# Plato's Madison

**Adaptive Reuse Apartment Project**

3841 E Washington Avenue, Madison, WI 53714

SHEET TITLE  
**CITY LANDSCAPE PLAN**

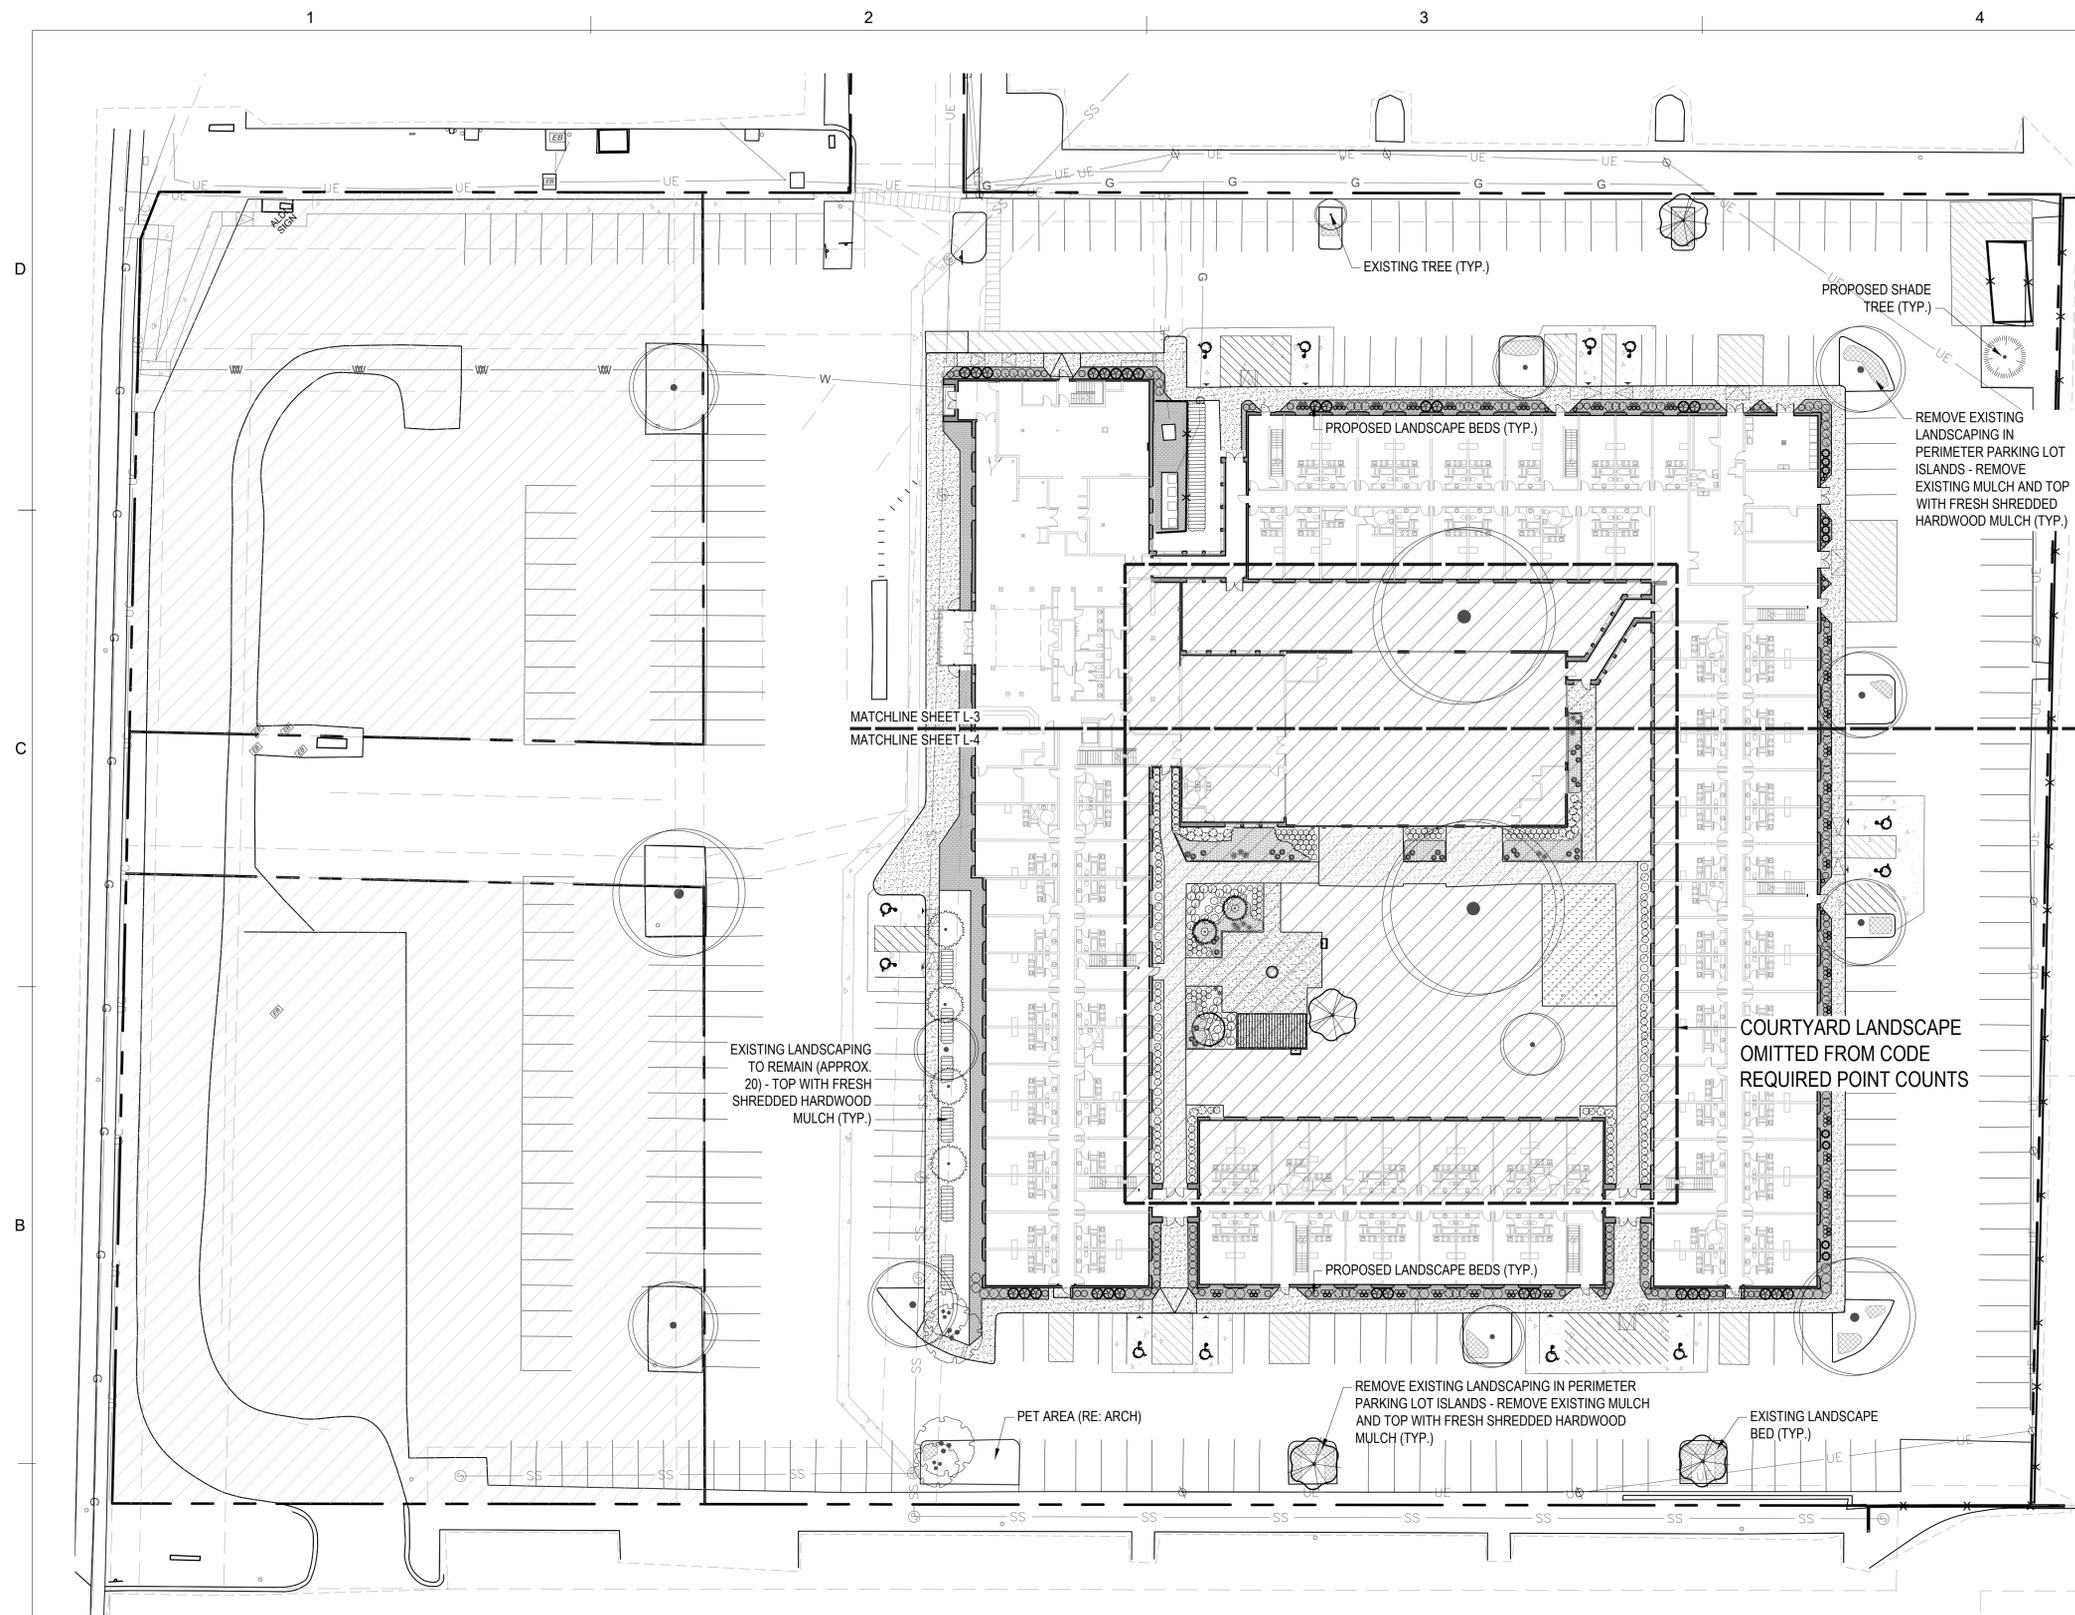
- The applicant shall provide a landscape plan as part of the Final Approval application, including plantings in the courtyard space and the use of bark mulch.

We have updated the courtyard landscaping significantly. Where there is exposed earth or mulch beds in the landscape islands around the building, we will enhance the planting in those areas and add fresh bark mulch. This also includes bark mulch in the courtyard space.
